DONALD C. COOK NUCLEAR PLANT UNIT NO. 2

AMENDMENT TO FACILITY OPERATING LICENSE

Amendment No. 69
License No. DPR-74

SAFETY EVALUATION BY THE OFFICE OF NUCLEAR REACTOR REGULATION
RELATED TO AMENDMENT NO. 69 TO FACILITY OPERATING LICENSE NO. DPR-74

FIGURE 3.4-2

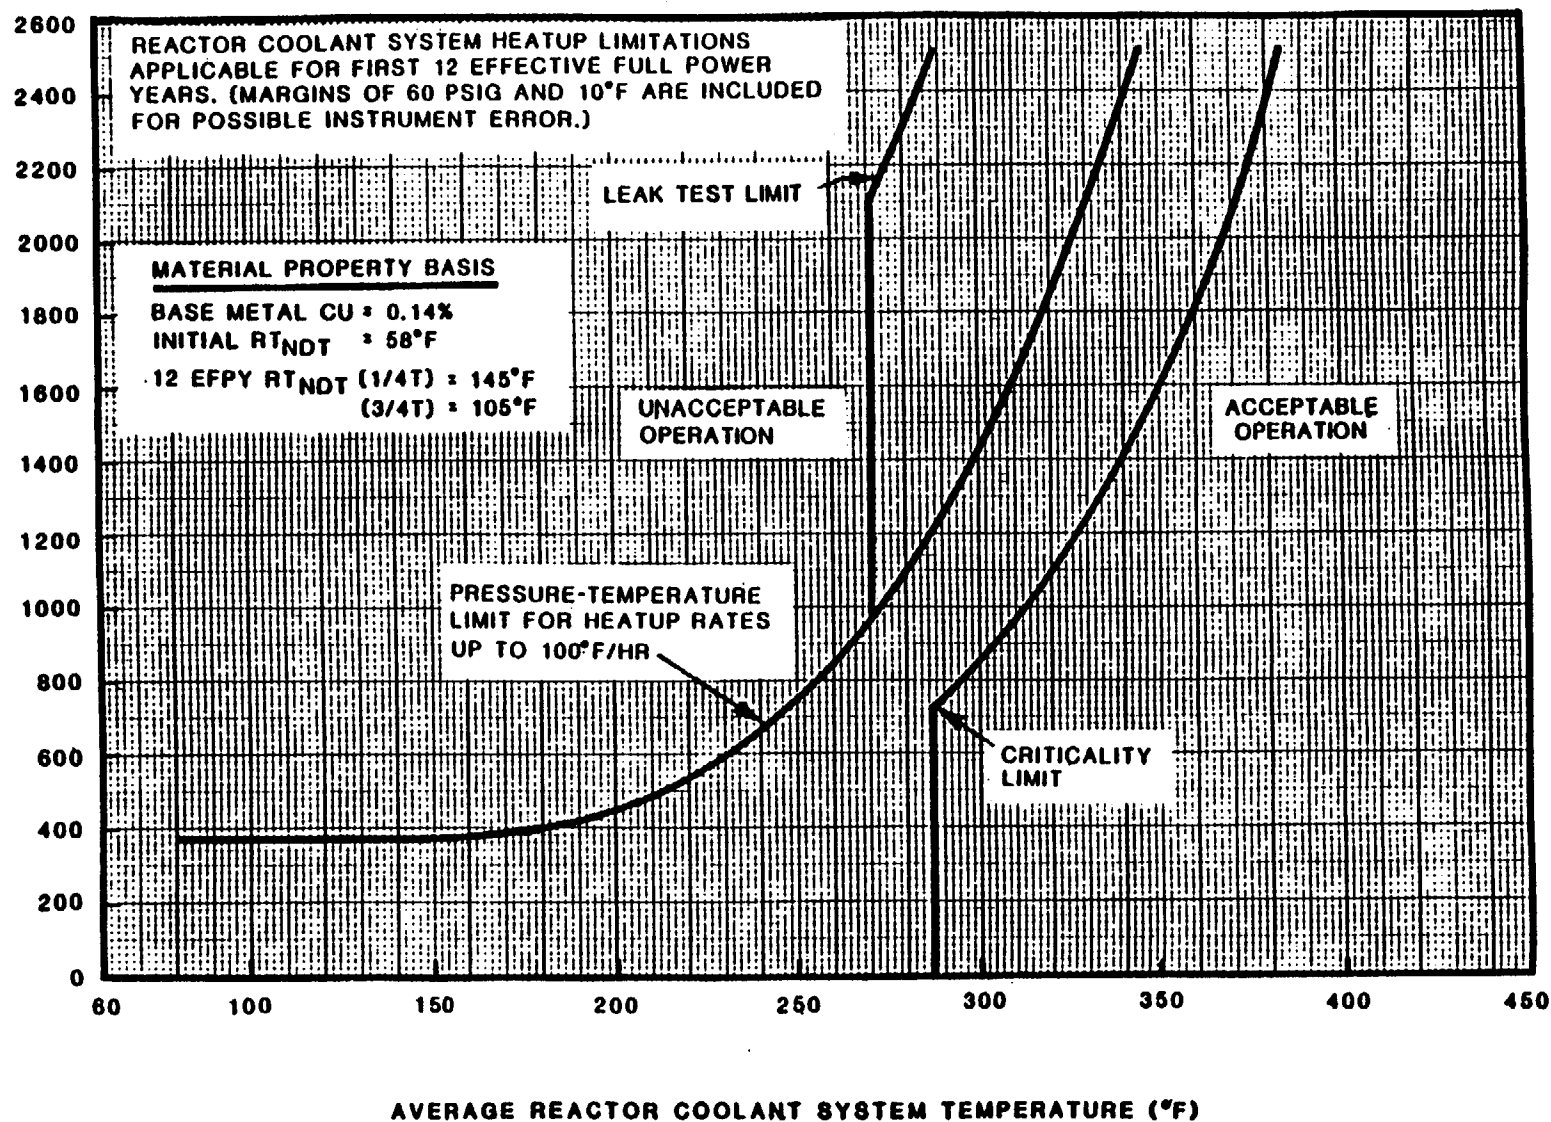
The amendment revises the Technical Specifications by changes to the heatup and cooldown curves to reflect the most current reactor vessel material surveillance capsule analysis.

The heatup limit curve, Figure 3.4-2, is a composite curve which was prepared by determining the most conservative case, with either the inside or outside wall controlling, for any heatup rate up to 100°F per hour. The cooldown limit curves of Figure 3.4-3 are composite curves which were prepared based upon the same type analysis with the exception that the controlling location is always the inside wall where the cooldown thermal gradients tend to produce tensile stresses while producing compressive stresses at the outside wall. The heatup and cooldown curves were prepared based upon the most limiting value of the predicted adjusted reference temperature at the end of 12 EFPY.

The staff has used the method of calculating pressure-temperature limits in USNRC Standard Review Plan 5.3.2, NUREG-0800, Rev. 1, July 1981 to evaluate the proposed pressure-temperature limits. The amount of neutron irradiation damage to the limiting beltline material was estimated using the extrapolation method recommended in Regulatory Guide 1.99, Rev. 1. Our conclusion is that the proposed pressure temperature limits meet the safety margins of Appendix G, 10 CFR 50 for (12) twelve EFPY and may be incorporated into the DCCNP-2 technical specifications.
